Omaha Public Power District

The Omaha Public Power District received a telecopy from the Commission containing questions in regard to the report entitled "Fort Calhoun Cycle 6 Small Break ECCS Performance Evaluation at 1500 MWt", which was submitted to the Commission on May 21, 1980, in support of an Application for Amendment of Operating License ("Stretch Application") filed on July 17, 1979. Attached hereto are responses to the telecopy questions.

Responses to Questions on
Small Break LOCA

FIGURE 1
FAILURE CONDITION - LOSS OF AN EMERGENCY GENERATOR

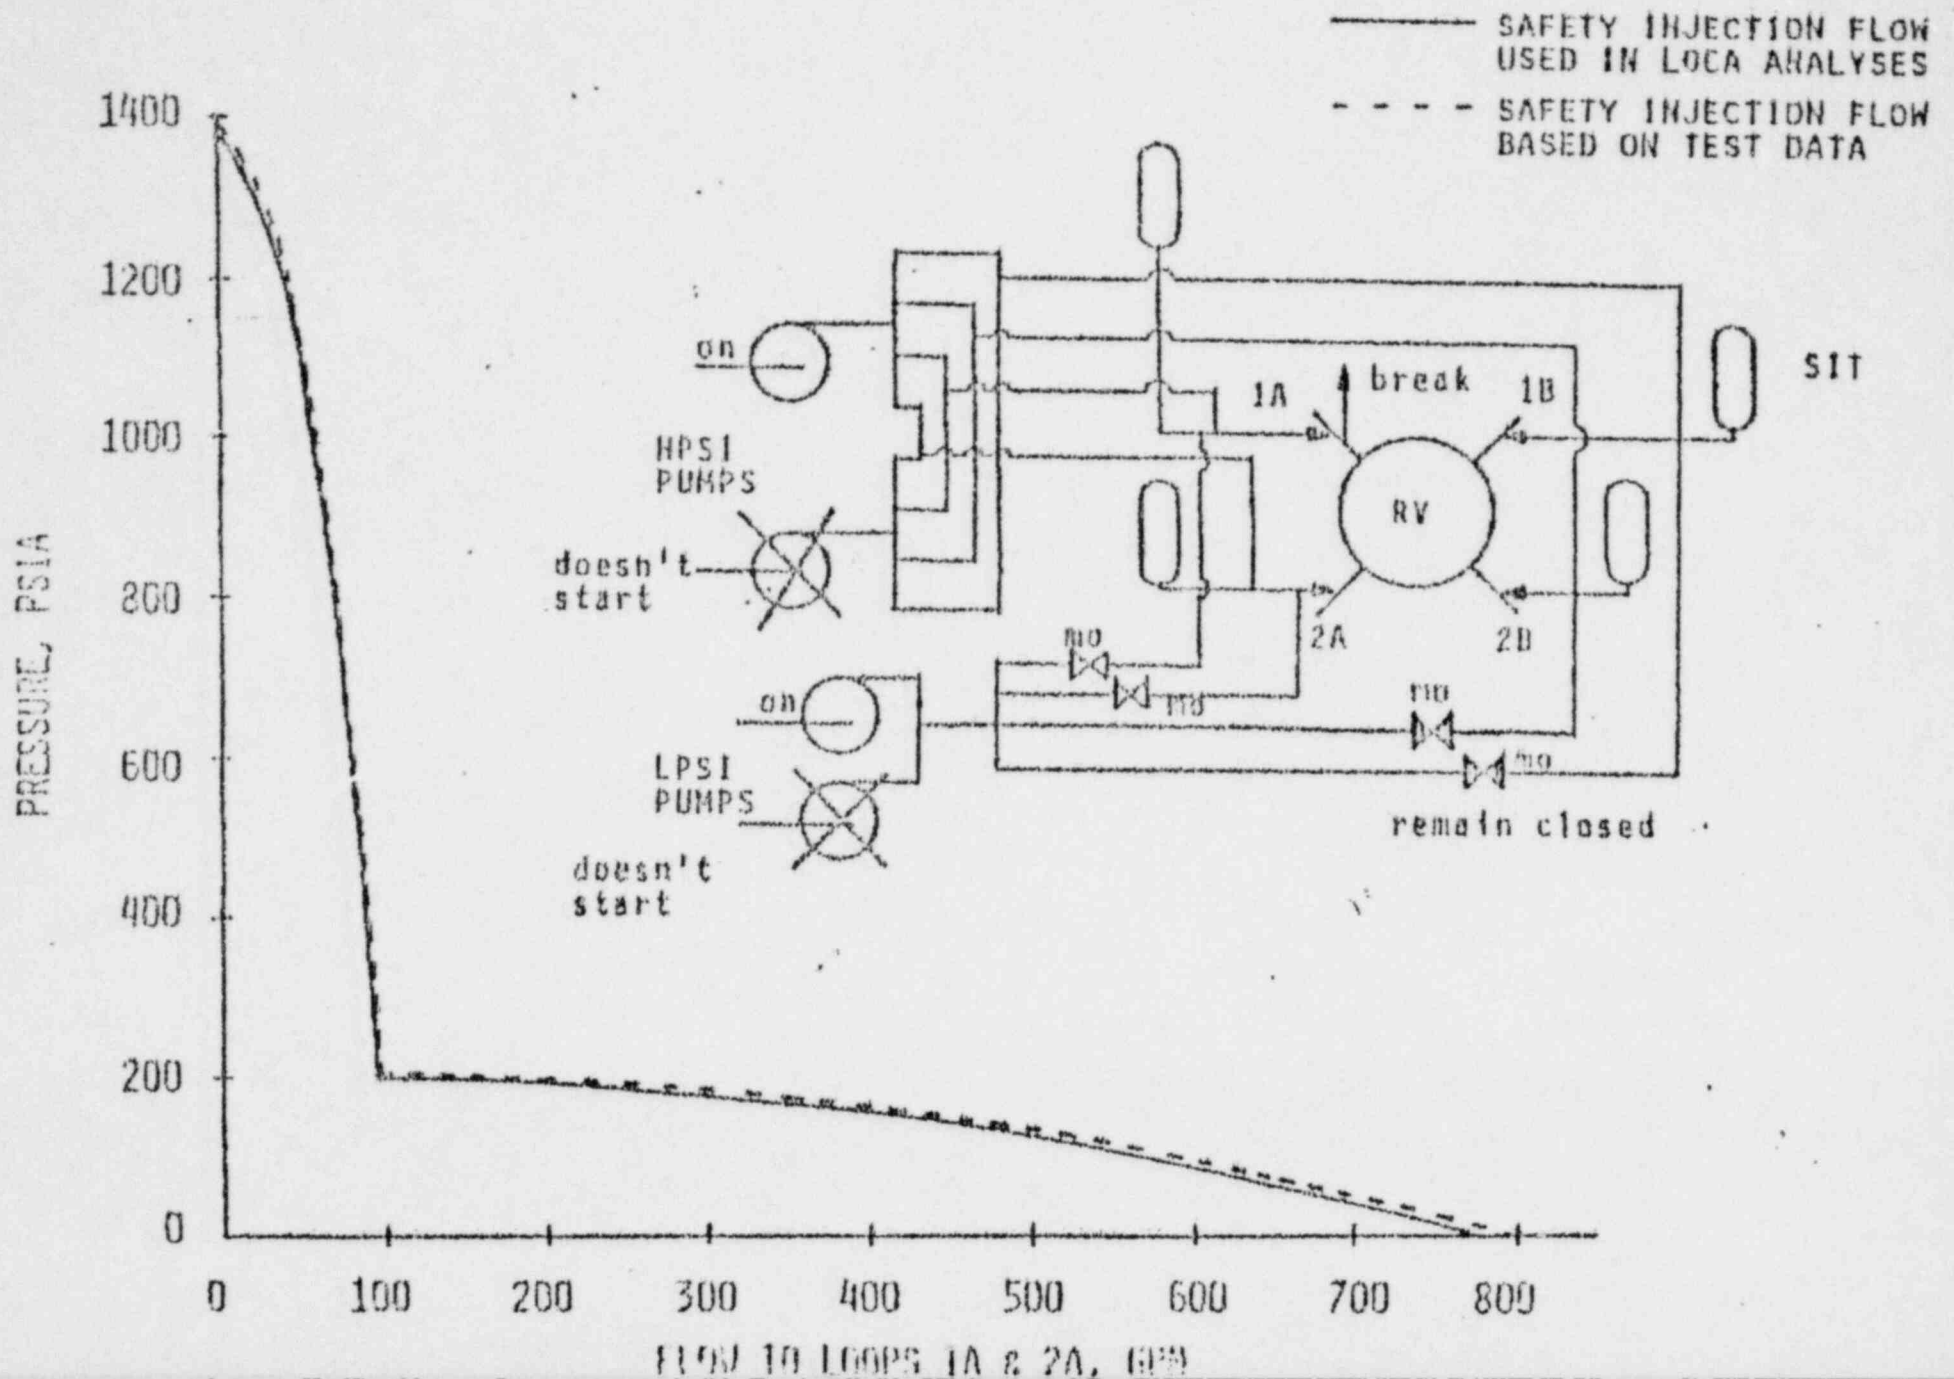
Provide justification, preferably experimental, for the "corrected low pressure SI pump flow" which has been assumed in the 0.5 ft break evaluation. Assure that the justification applies to the range of operational conditions under the hypothesized LOCA. Provide evaluation of the uncertainties in pump performance characteristics.

The high and low pressure safety injection performance curves, used in the small break LOCA analysis at 1530 MWt presented in Reference 1, were based on experimentally measured head and flow parameters. The safety injection flow credited in the Reference 1 analysis includes a 1% uncertainty in head and a 3% uncertainty in flow. The safety injection performance curves used in this analysis are shown in Figures 1 and 2.
